# SK<sup>®</sup> 48-RE

## 2003-2008 Diesel & V10

## Corrected Hole Drilling

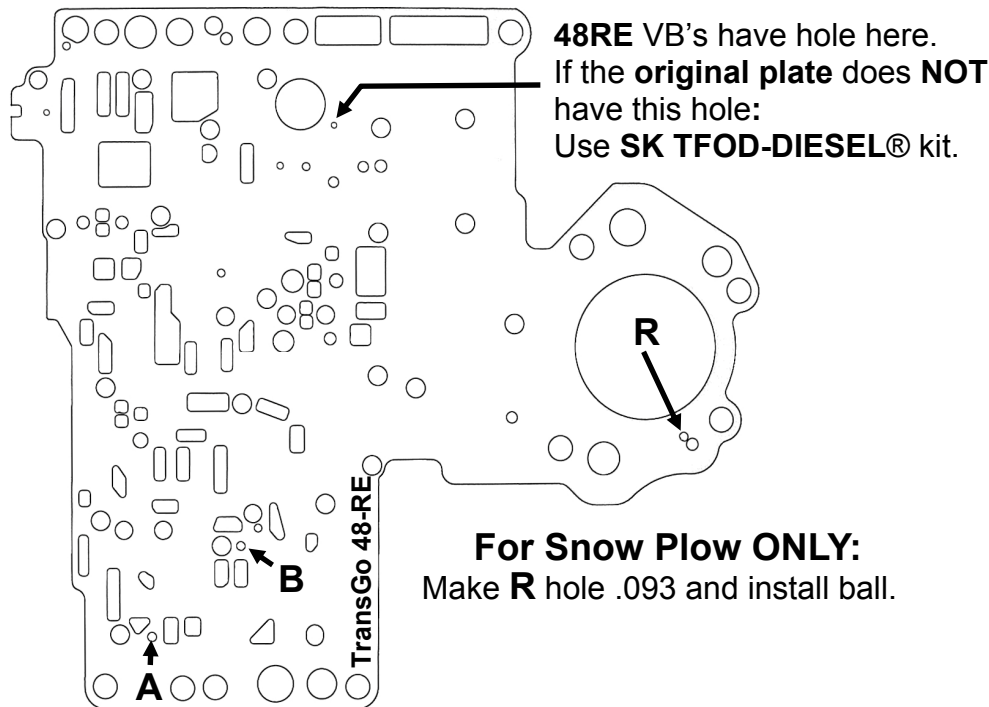
**Use this for correct hole locations.**  
A limited number of kits were released with  
hole "B" arrow pointing slightly up and to the  
right of its normal location.  
We apologize for the error and any  
inconvenience this may have caused.

48RE VB's have hole here.  
If the **original plate** does **NOT**  
have this hole:  
Use **SK TFOD-DIESEL<sup>®</sup>** kit.

**For Snow Plow ONLY:**  
Make **R** hole .093 and install ball.

Enlarge holes A & B  
with .106 drill. Re-Install  
original check balls.
